**Town of Kittery  
 Planning Board Meeting  
 July 27, 2023**

**ITEM 3 – 24 Foyes Lane– Shoreland Development Plan Review**

Staff reviewed the submitted application and plan and have the following comments:

**SHORELAND DEVELOPMENT PLAN**  
 FOR PROPERTY AT  
**24 Foyes Lane**  
 Kittery Point, York County, Maine  
 OWNED BY  
**Marshlark, LLC**  
 c/o Ellen Denny & Andrew Wallace  
 24 Foyes Lane, Kittery Point, ME 03905

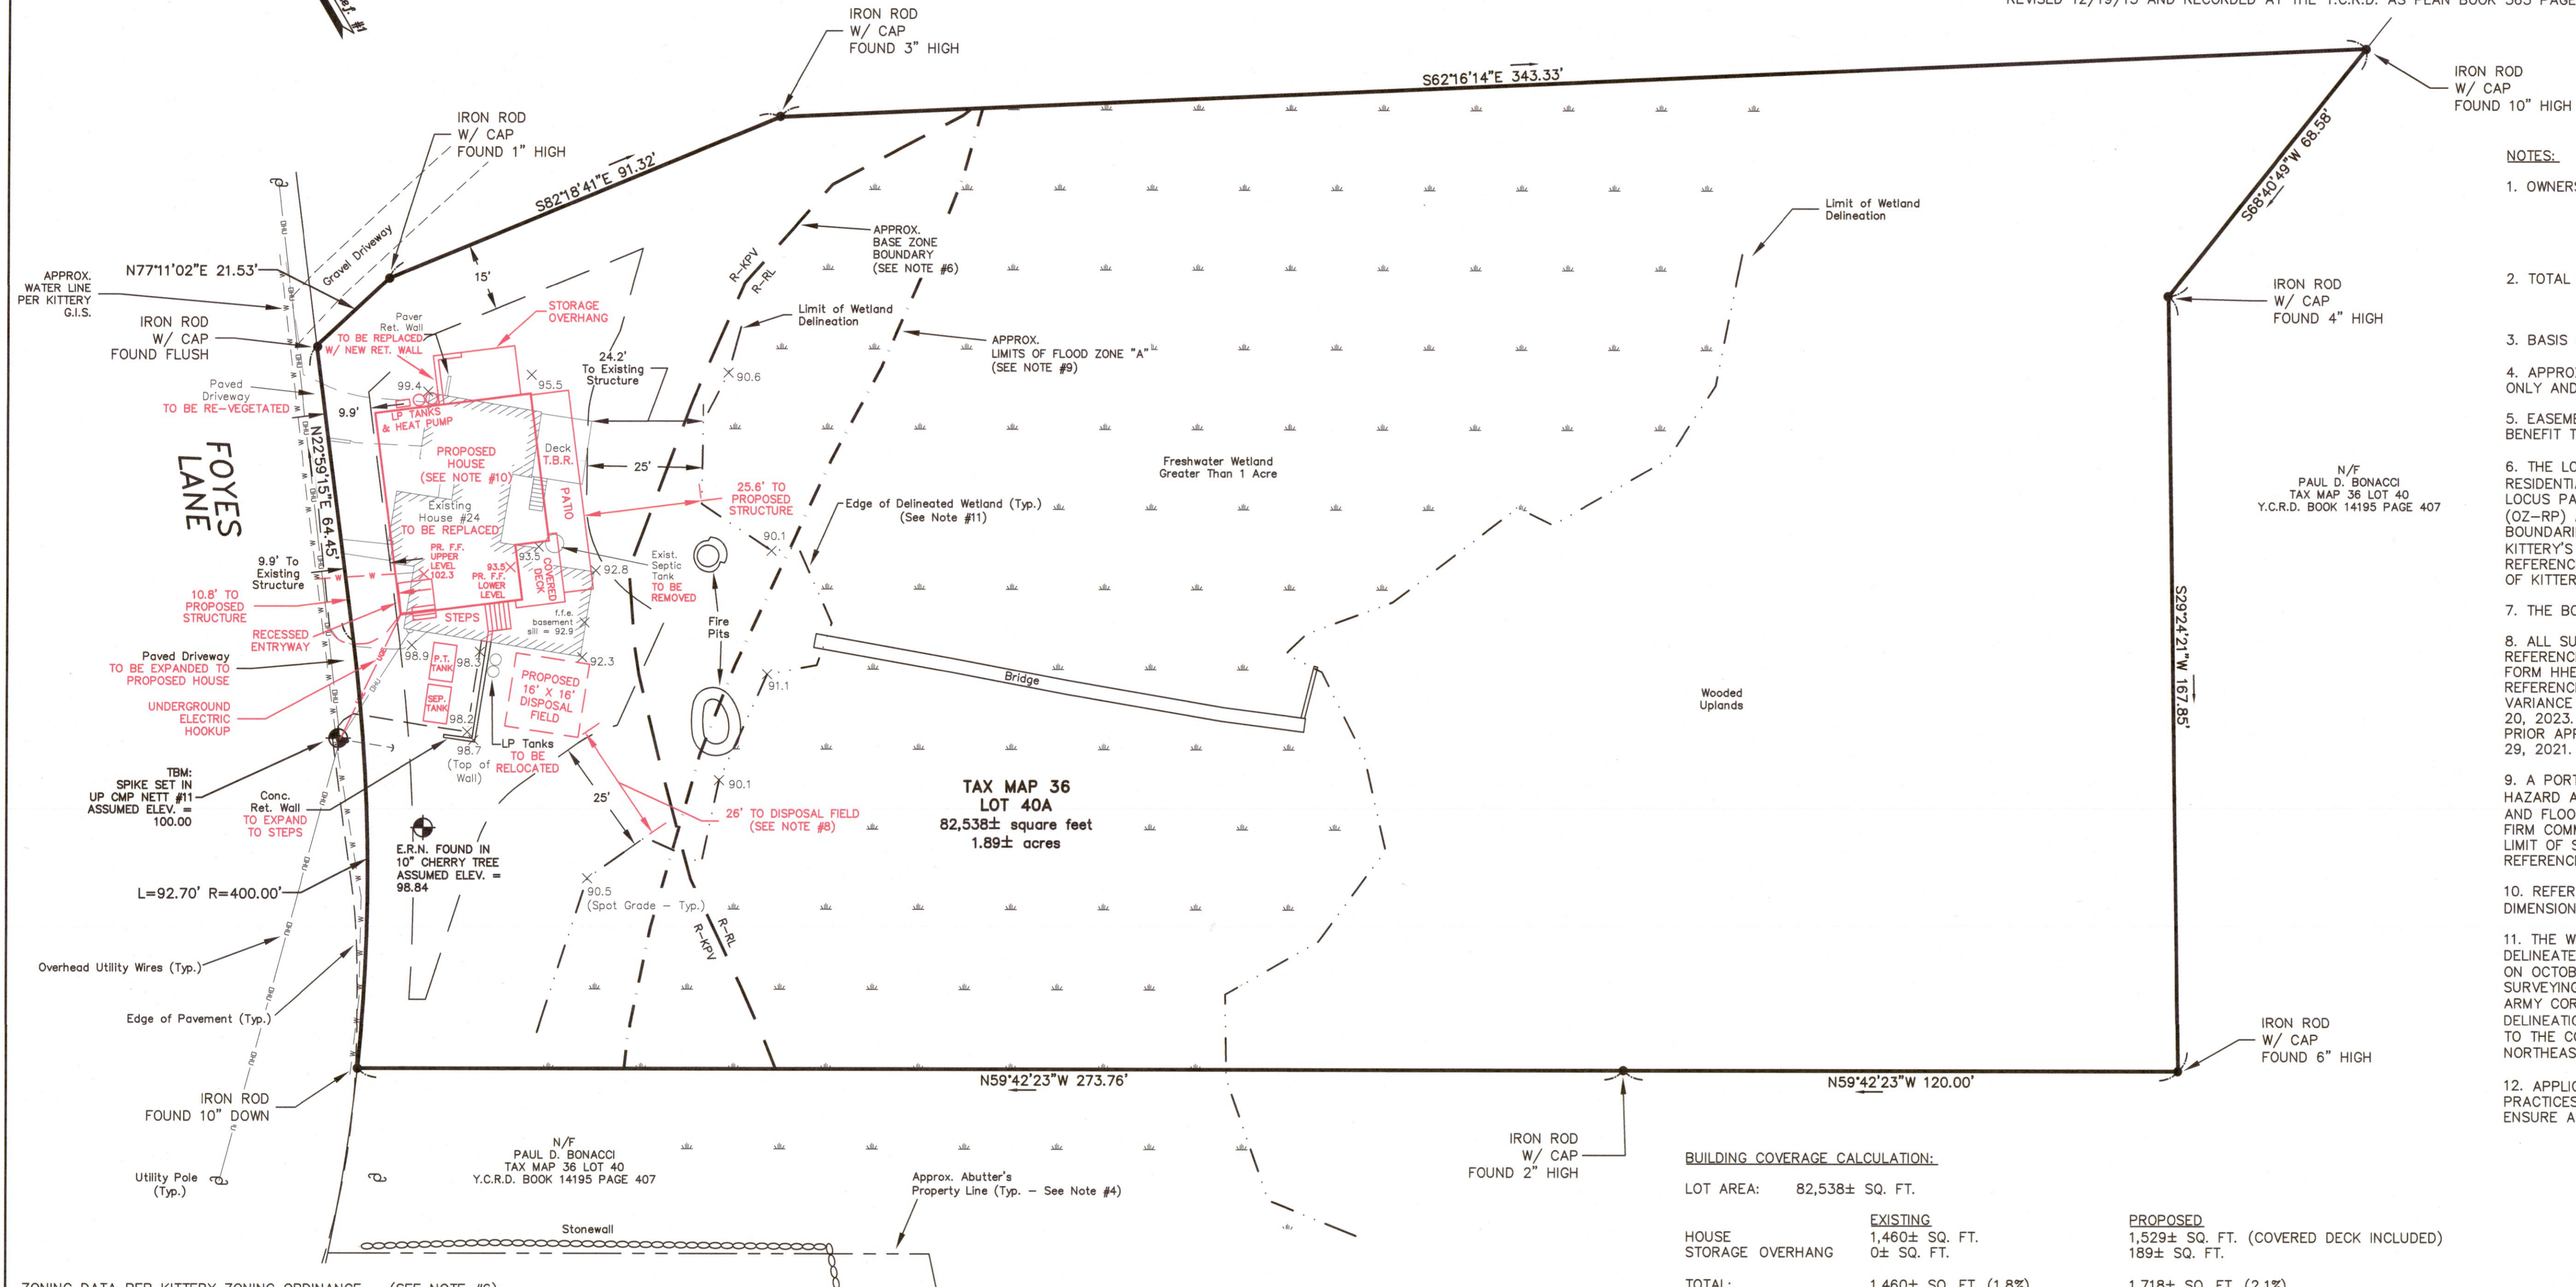
- 38 3. The existing septic tank would be pumped out before removal. The proposed wastewater disposal  
 39 field would maintain a 26’ setback, while the proposed septic and pre-treatment tanks would be  
 40 further from the wetland and rest behind a retaining wall, as shown on the site plan.

- 41 4. General provision §16.1.8.C.4.(b). requires expansion of structures within the base zone setback  
 42 in the shoreland or resource protection overlay zones not exceed 30% of the total footprint of  
 43 structures existing within the property on January 1, 1989. The existing structure footprint is  
 44 1,460 sq ft. The proposed plan would provide and expansion of 296 sq ft, or 20.3%, within the  
 45 allowable limit.

- 46 a. The site plan notates an existing deck of 173 sq ft. This deck was not included in the  
 47 structure expansion calculations as it was built after January 1<sup>st</sup>, 1989.

- 48 b. The proposed patio is not included in structure expansion calculations, as it is not  
 49 considered a structure in relation to these expansion calculations.

- 50 5. The Shoreland Overlay Zone Ordinance §16.4.28.E.(3).(a). requires new principal and accessory  
 51 structures to be set back at least 100 feet, horizontal distance, from the normal high-water line of  
 52 any water bodies, tributary streams, the upland edge of a coastal wetland, or the upland edge of a  
 53 freshwater wetlands. The proposed new development would increase this setback from 24.2’ to  
 54 25.6’, reducing the non-conformity of the structure while not also reducing the non-conformity of  
 55 the front yard setback.

- 56 6. §16.4.28.E.(2). allows 20% of total lot area in the shoreland or resource protection overlay zones  
 57 to be comprised of non-vegetated surfaces or structures. With a lot size of 82,538 sq ft, current  
 58 devegetation sits at 2,499, or 3%. The proposed plan would increase devegetation to 2,814 sq ft, or  
 59 3.4%, well within the allowable limit.

- 60 a. The bridge notated on the site plan is not included in devegetated surface calculations as it  
 61 is beneath the edge of the delineated wetland.
